To: Planning Committee

File: RZ 13-638387

Re: **Application by Konic Development Ltd. for Rezoning at 7151 No. 2 Road from Single Detached (RS1/E) to Low Density Townhouses (RTL4)**

Staff Report

Tree Retention & Removal Plan, Scale 1/16" = 1'

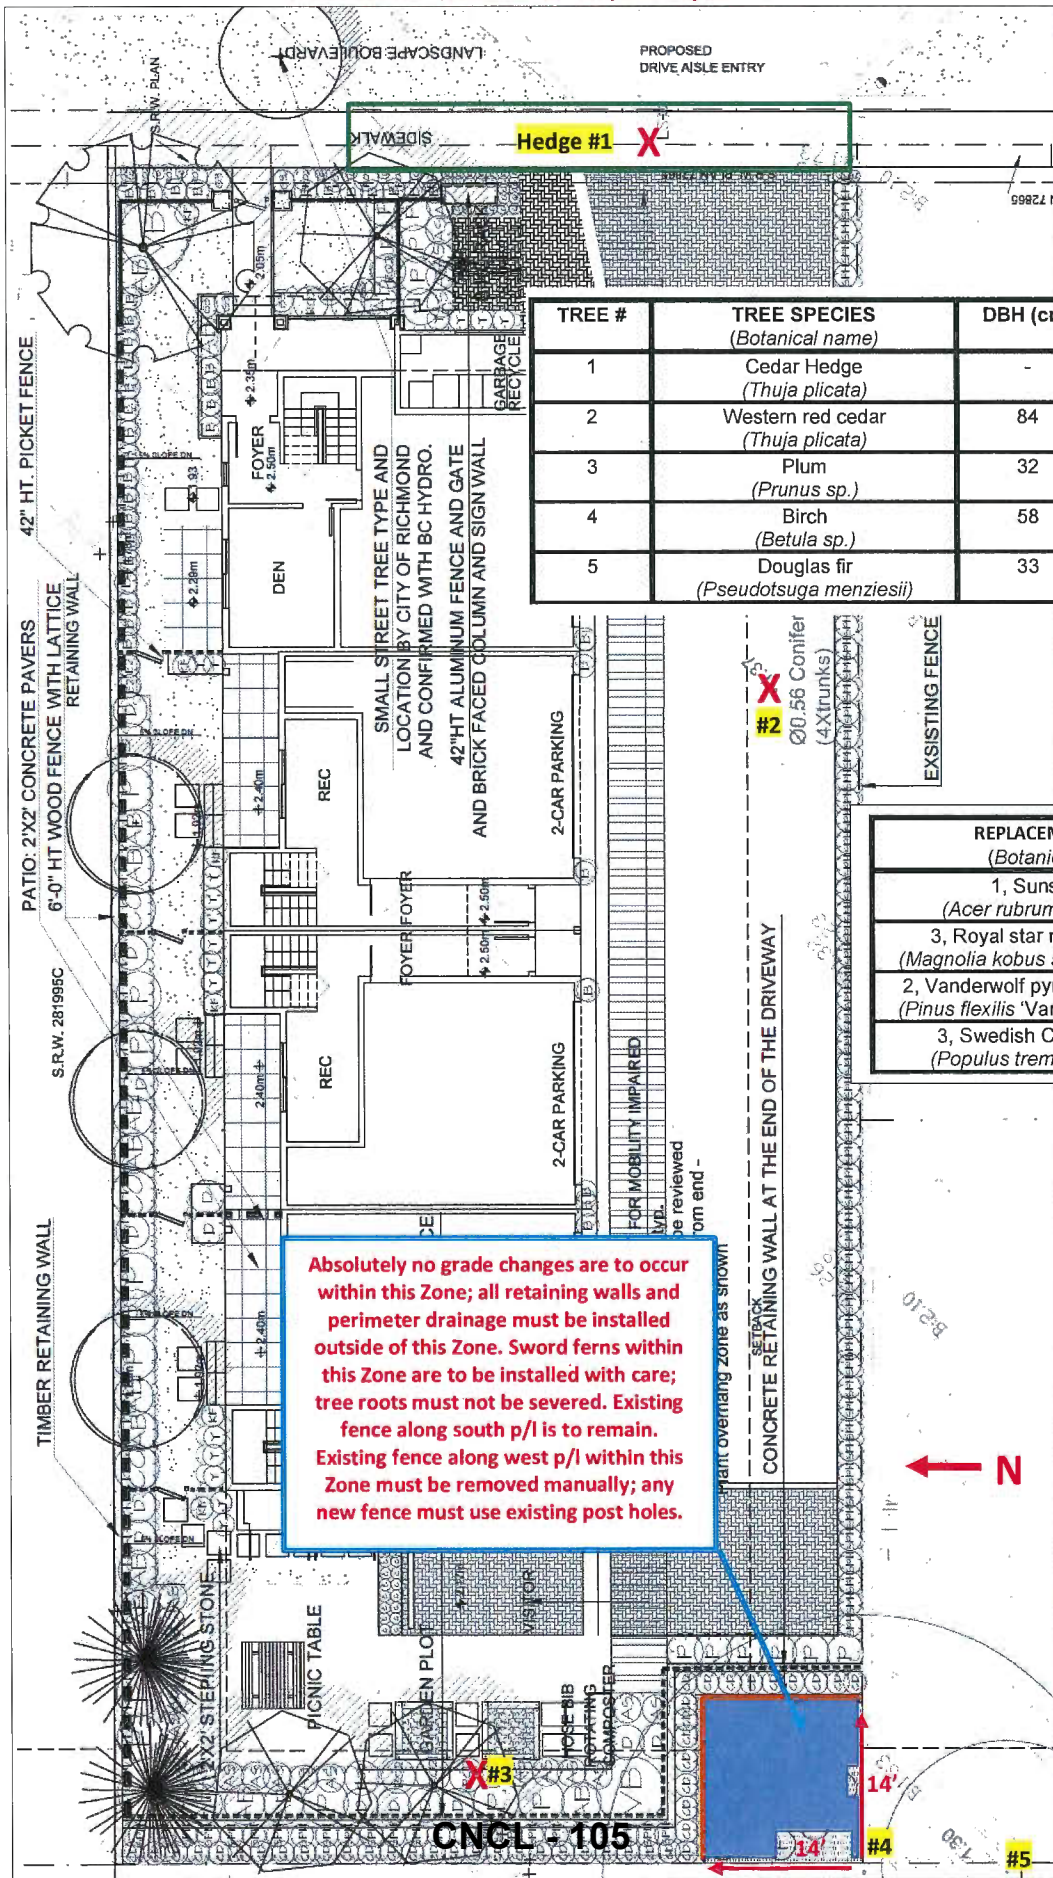
- One Western Red Cedar tree (tag# 2) and one Plum tree (tag# 3) located on the development site are infected with Fungal Blight and have been previously topped. As a result, these trees are not good candidates for retention and should be removed and replaced.

- One Birch tree (tag #4) and one Douglas Fir tree (tag #5) located on the adjacent property to the west are identified to be retained and protected. Provide tree protection as per City of Richmond Tree Protection Information Bulletin Tree-03.

- Replacement trees should be specified at 2:1 ratio as per the OCP.
- One cedar hedge on city's boulevard along the east property line of the site will be in conflicts with proposed vehicle access. Parks Operations staff agreed to the proposed removal based on the health and condition of the trees, as well as the required frontage improvement works along No. 2 Road. No compensation is required.

The applicant wishes to remove two on-site trees (tag# 2 & 3). The 2:1 replacement ratio would require a total of four replacement trees. According to the Preliminary Landscape Plan provided by the applicant (Attachment 2), the developer is proposing to plant nine new trees on-site. The size and species of replacement trees will be reviewed in detail through Development Permit and overall landscape design.

Two trees (tag # 4 & 5) on the neighbouring property at to the west are to be retained and protected. To ensure that the trees identified for retention are protected at development stage, the applicant is required to complete the following items:
